Overlook Parkway Water Main Extension Project
Solicitation Number: CO-00415-SM
Job No.: 20-7003

ADDENDUM 1
September 2, 2021

24" PLAN AND PROFILE SHEET
STA 37+00 TO STA 40+70.77

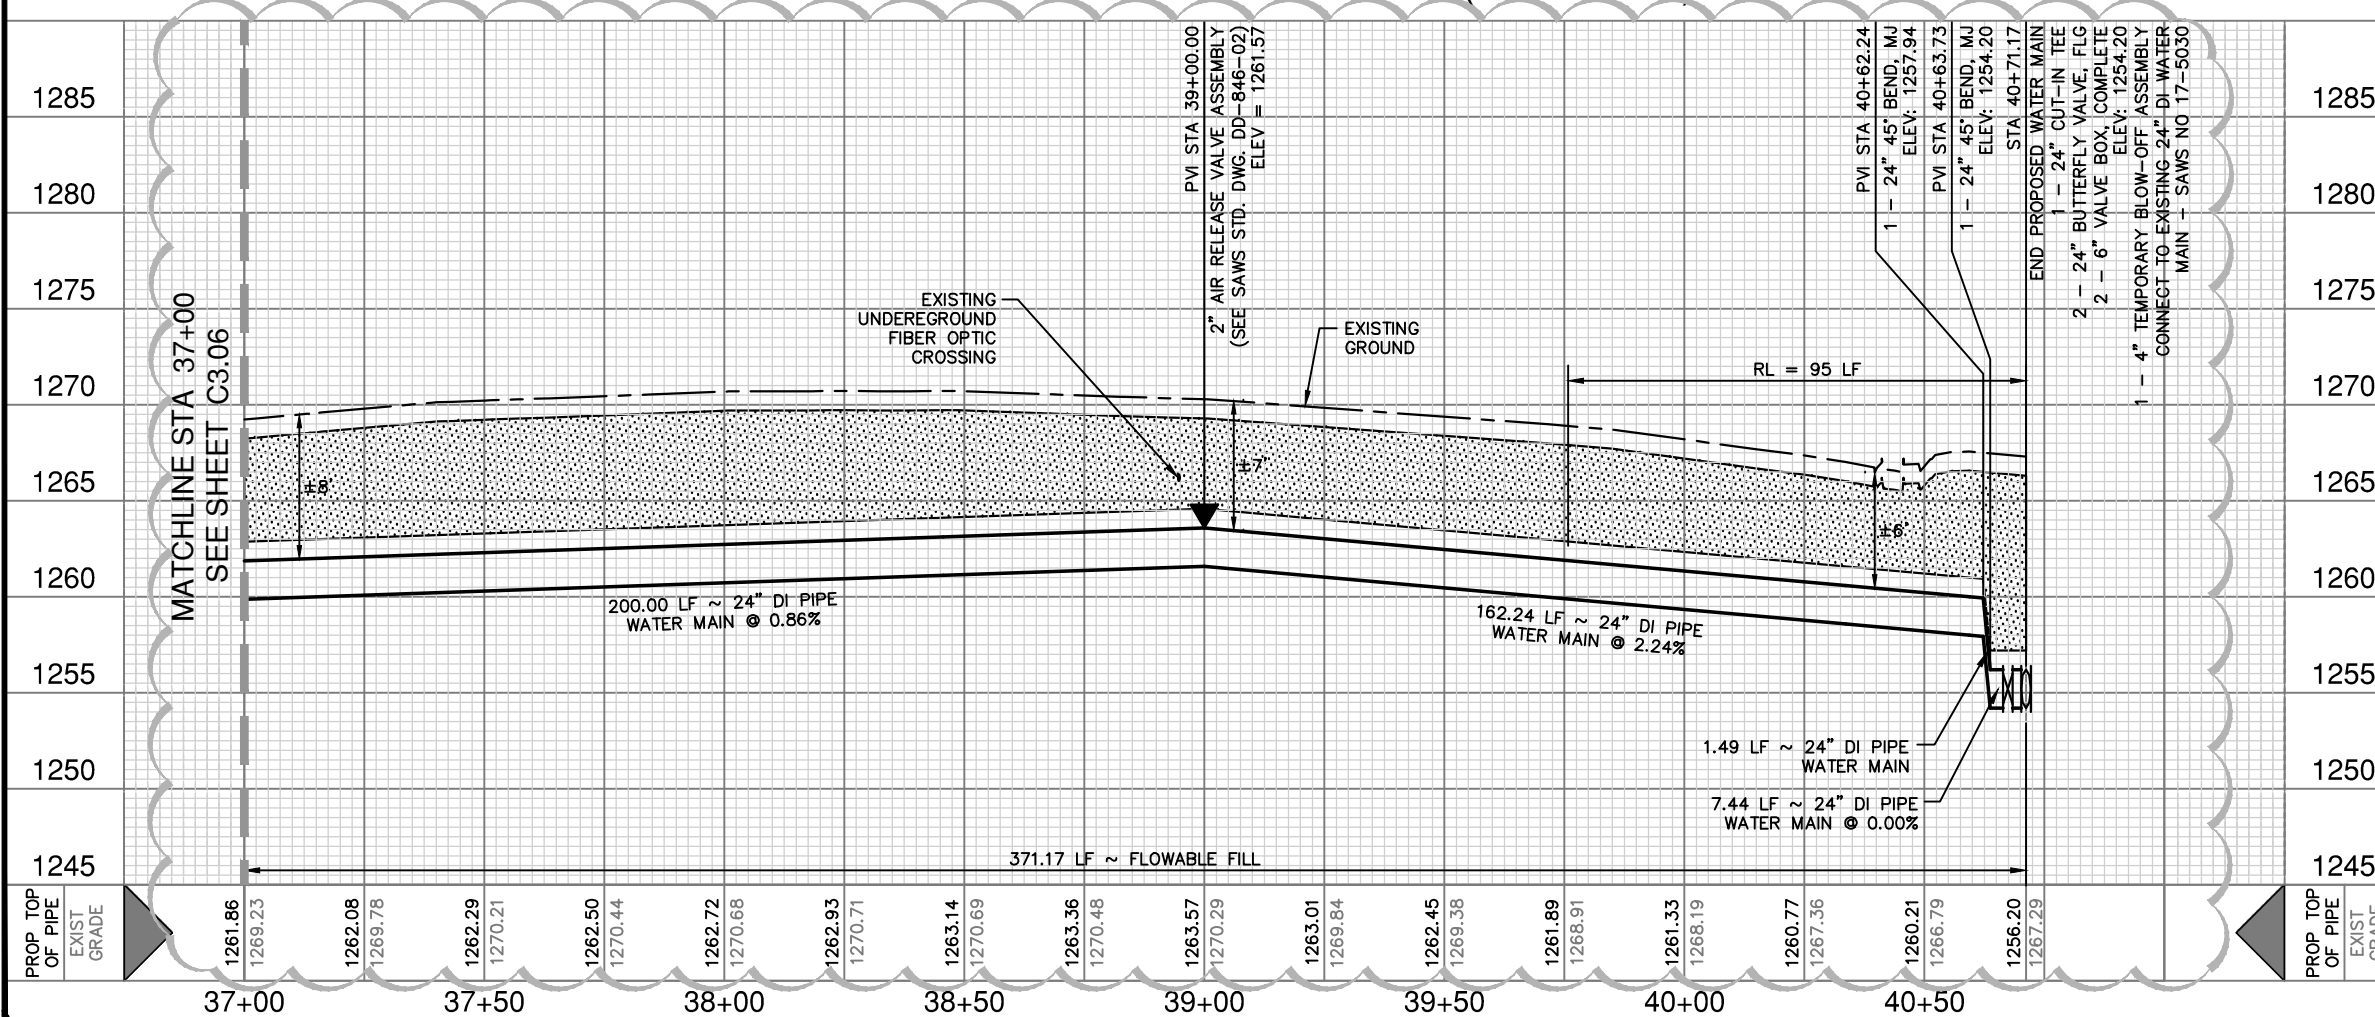
- o Revise quantity of Item 413 - Flowable Fill to be 243 CY
 - o Revise quantity of Item 836.0 - Pipe fittings, All Sizes and Types to be 1.44 Ton
9. Sheet C3.07: 24" Plan and Profile Sheet STA 37+00 to STA 40+70.77- Replace sheet in its entirety.

- o Revised Profile of existing 24" Water main
 - o Revised quantity of Item 413 - Flowable Fill
 - o Revised quantity of Item 836.0 – Pipe Fittings, All Sizes and Types

PLAN SHEET
STA 14+00 TO 16+75.18

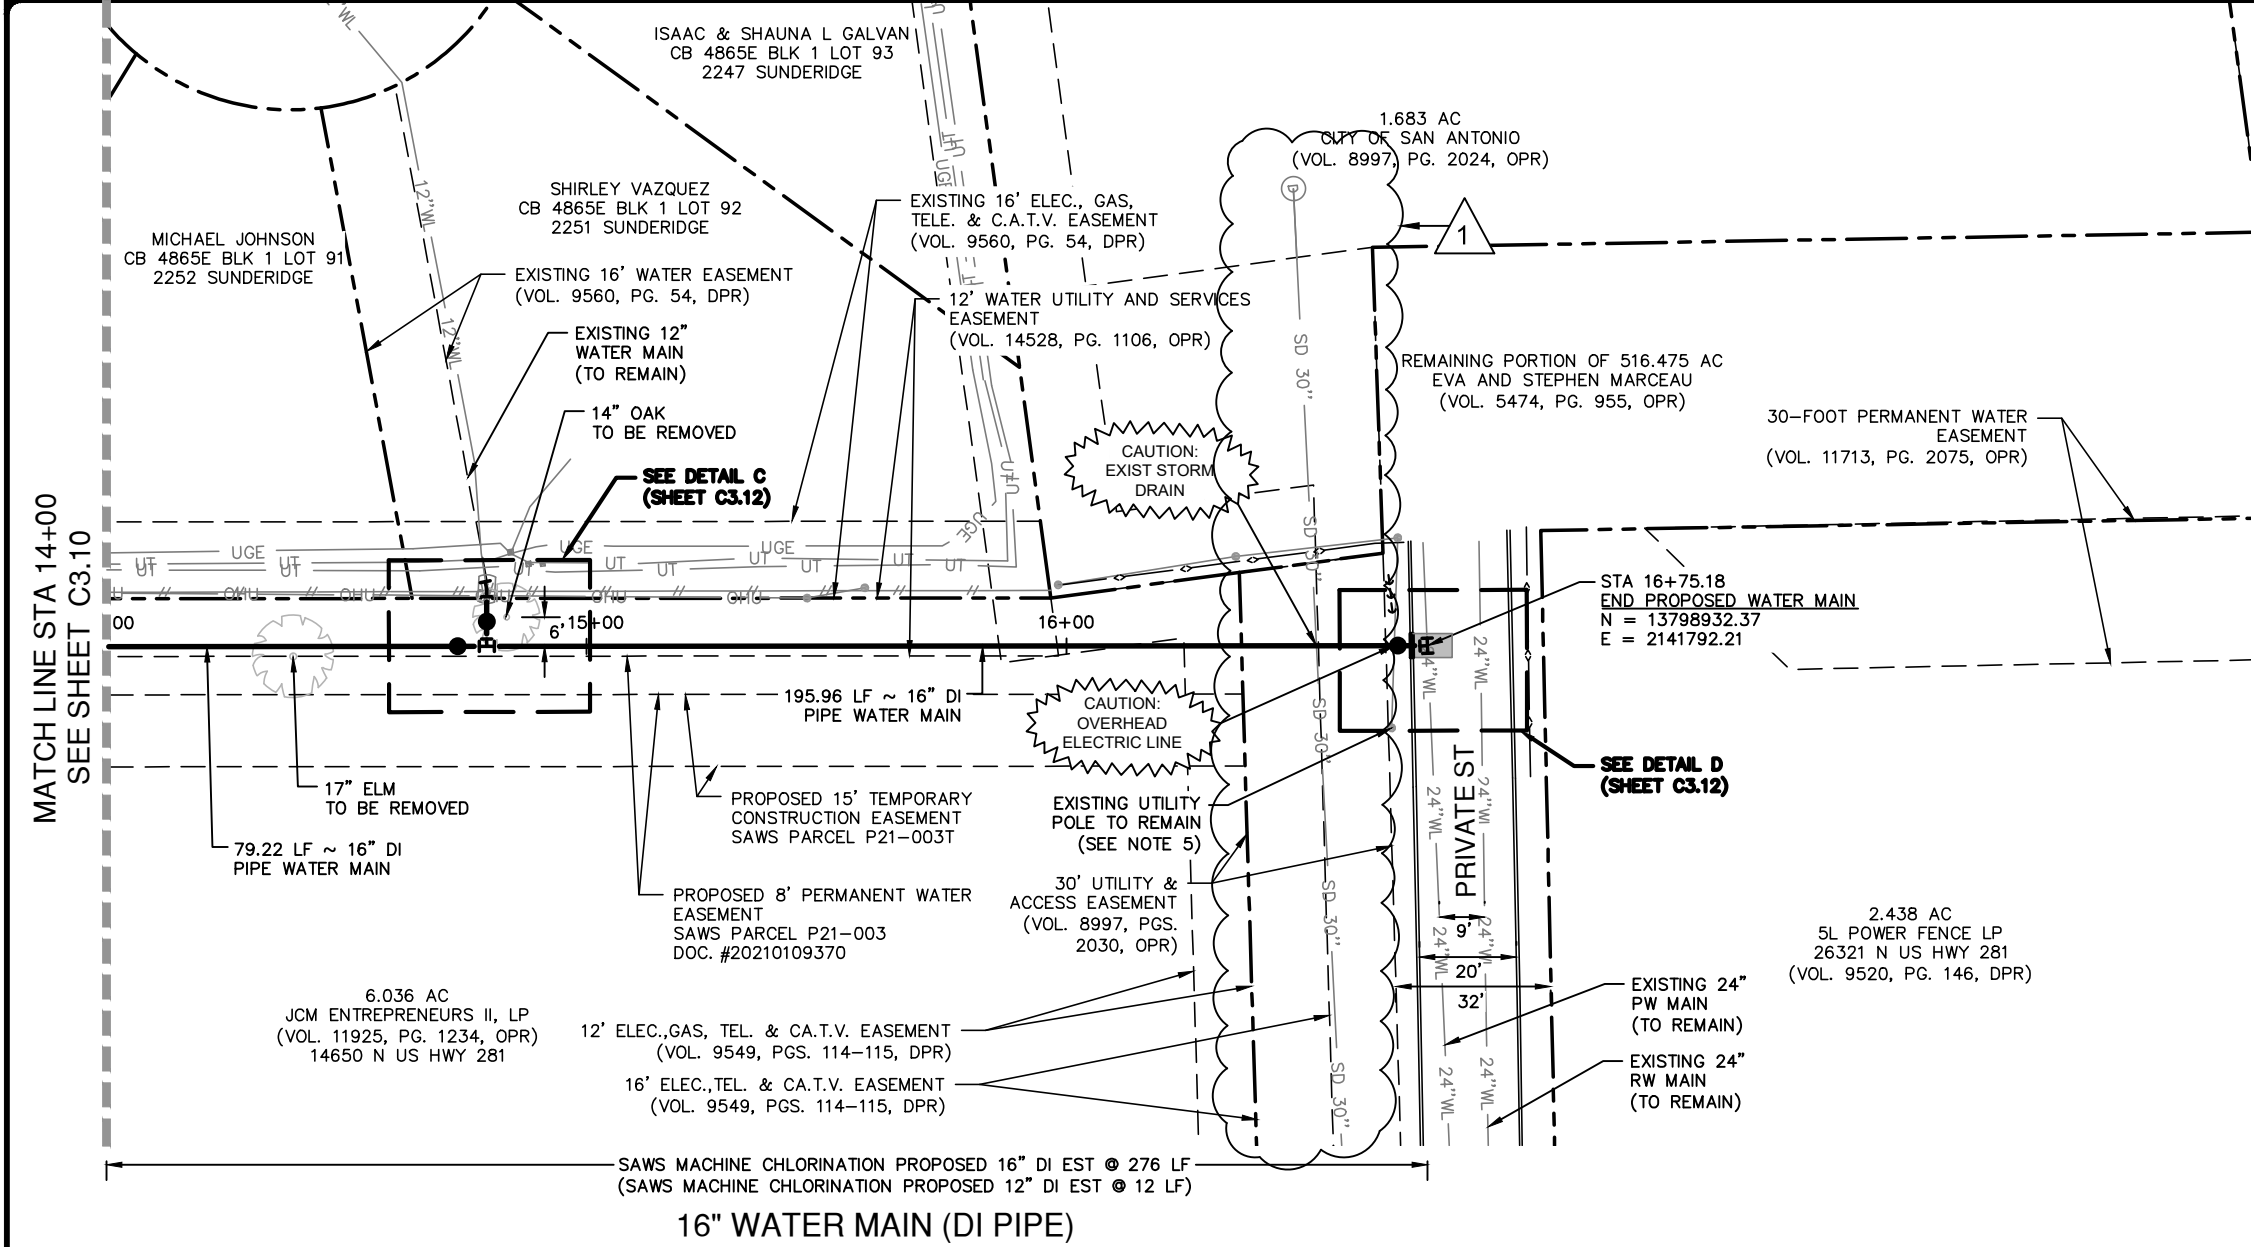
10. Sheet C3.11: Plan Sheet STA 14+00 to 16+75.18 - Replace sheet in its entirety.
 - o Revised call out size of existing storm drain
